Release Notes for SANtricity ES Storage Manager 10.86 for E-Series Storage Systems and the EF540 Flash Array

Part number: 215-07663_C0
May, 2014

Figure 1 LEDs on the Left Bezel

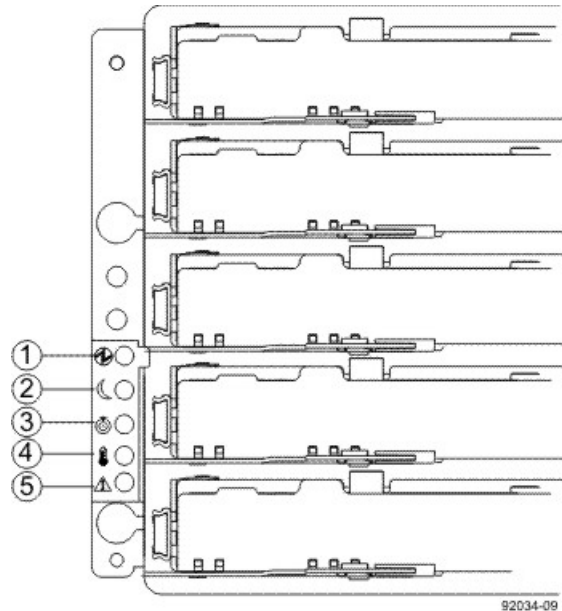
The call-outs in the figure do not match the description in the table on page 94.

Table 1 LEDs on the Left Bezel

Location	LED	Color	On	Off
1	Power	Green	Power is present.	Power is not present.
2	Standby Power	Green	The controller-drive tray is in Standby Power mode.	The controller-drive tray is not in Standby Power mode.
3	Controller-drive tray Locate	White	Identifies a controller-drive tray that you are trying to find.	Normal status.
4	Controller-drive tray Over-Temperature	Amber	The temperature of the controller-drive tray has reached an unsafe level.	Normal status.
5	Service Action Required	Amber	A component within the controller-drive tray needs attention.	Normal status.

Figure 2 LEDs on the Left Bezel

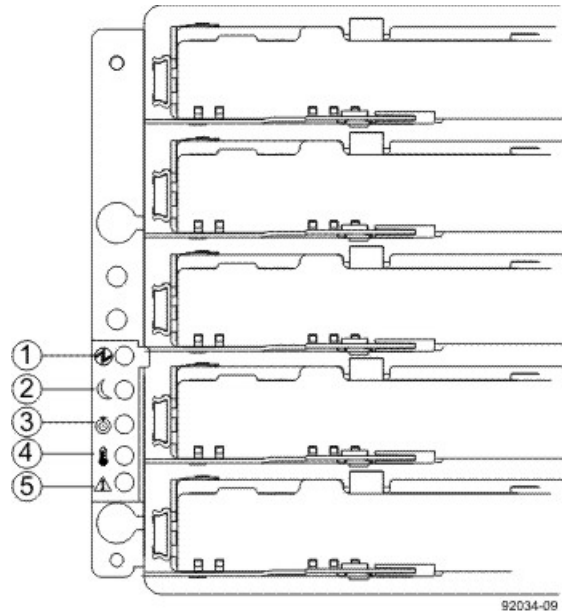
The call-outs in the figure do not match the description in the table on page 2.

Table 2 LEDs on the Left Bezel

Location	LED	Color	On	Off
1	Power	Green	Power is present.	Power is not present.
2	Standby Power	Green	The controller-drive tray is in Standby Power mode.	The controller-drive tray is not in Standby Power mode.
3	Controller-drive tray Locate	White	Identifies a controller-drive tray that you are trying to find.	Normal status.
4	Controller-drive tray Over-Temperature	Amber	The temperature of the controller-drive tray has reached an unsafe level.	Normal status.
5	Service Action Required	Amber	A component within the controller-drive tray needs attention.	Normal status.

Figure 3 LEDs on the Left Bezel

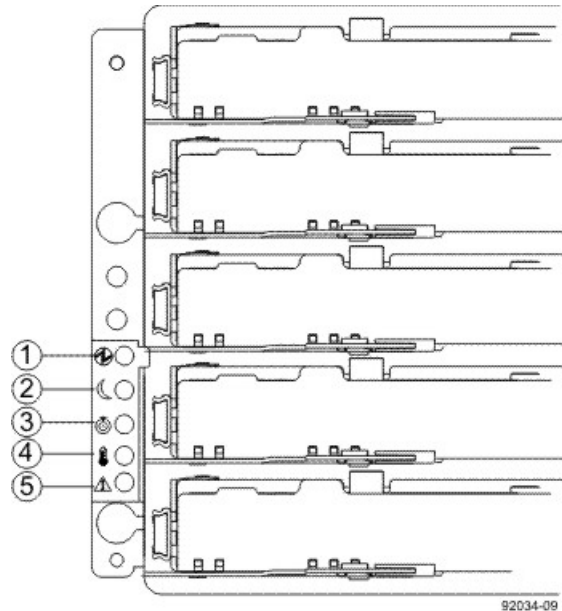
The call-outs in the figure do not match the description in the table on pages 1 and 2.

Table 3 LEDs on the Left Bezel

Location	LED	Color	On	Off
1	Power	Green	Power is present.	Power is not present.
2	Standby Power	Green	The controller-drive tray is in Standby Power mode.	The controller-drive tray is not in Standby Power mode.
3	Controller-Drive Tray Locate	White	Identifies a controller-drive tray that you are trying to find.	Normal status.
4	Controller-Drive Tray Over-Temperature	Amber	The temperature of the controller-drive tray has reached an unsafe level.	Normal status.
5	Service Action Required	Amber	A component within the controller-drive tray needs attention.	Normal status.

Figure 4 LEDs on the Left Bezel

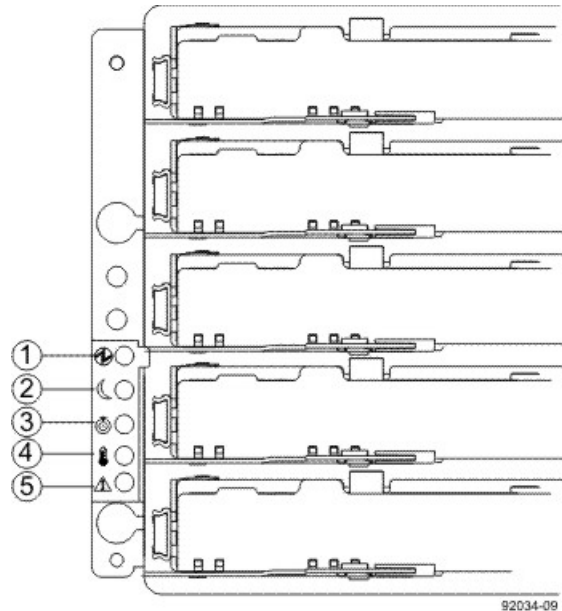
The call-outs in the figure do not match the description in the table on pages 1 and 2.

Table 4 LEDs on the Left Bezel

Location	LED	Color	On	Off
1	Power	Green	Power is present.	Power is not present.
2	Standby Power	Green	The controller-drive tray is in Standby Power mode.	The controller-drive tray is not in Standby Power mode.
3	Controller-Drive Tray Locate	White	Identifies a controller-drive tray that you are trying to find.	Normal status.
4	Controller-Drive Tray Over-Temperature	Amber	The temperature of the controller-drive tray has reached an unsafe level.	Normal status.
5	Service Action Required	Amber	A component within the controller-drive tray needs attention.	Normal status.

Figure 5 LEDs on the Left Bezel

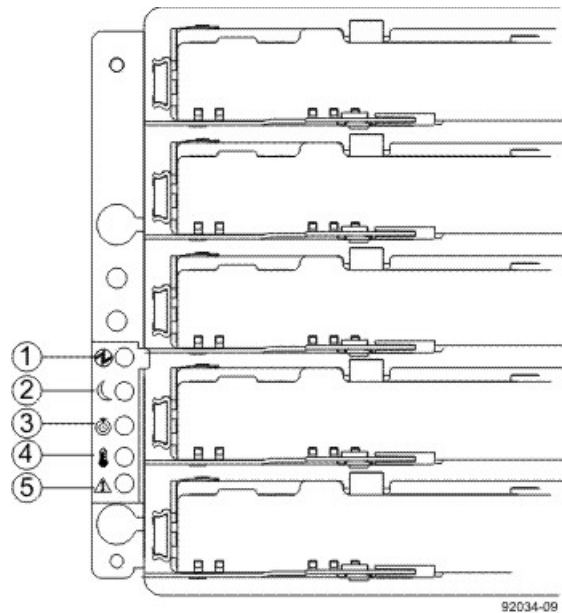
The call-outs in the figure do not match the description in the table on page 106.

Table 5 LEDs on the Left Bezel

Location	LED	Color	On	Off
1	Drive Tray Power	Green	Power is present.	Power is not present.
2	Drive Tray Standby Power	Green	The drive tray is in Standby Power mode.	The drive tray is not in Standby Power mode.
3	Drive Tray Locate	White	Identifies a drive tray that you are trying to find.	Normal status.
4	Drive Tray Over-Temperature	Amber	The temperature of the drive tray has reached an unsafe level.	Normal status.
5	Drive Tray Service Action Required	Amber	A component within the drive tray needs attention.	Normal status.

Figure 6 LEDs on the Left Bezel

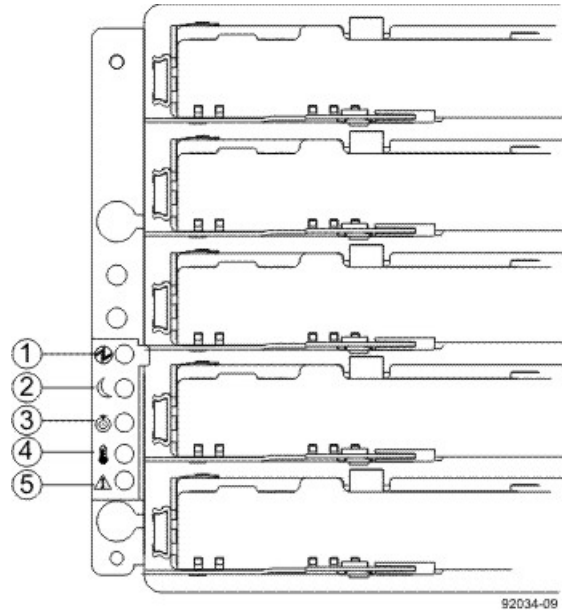
The call-outs in the figure do not match the description in the table on pages 1 and 2.

Table 6 LEDs on the Left Bezel

Location	LED	Color	On	Off
1	Drive Tray Power	Green	Power is present.	Power is not present.
2	Drive Tray Standby Power	Green	The drive tray is in Standby Power mode.	The drive tray is not in Standby Power mode.
3	Drive Tray Locate	White	Identifies a drive tray that you are trying to find.	Normal status.
4	Drive Tray Over-Temperature	Amber	The temperature of the drive tray has reached an unsafe level.	Normal status.
5	Drive Tray Service Action Required	Amber	A component within the drive tray needs attention.	Normal status.
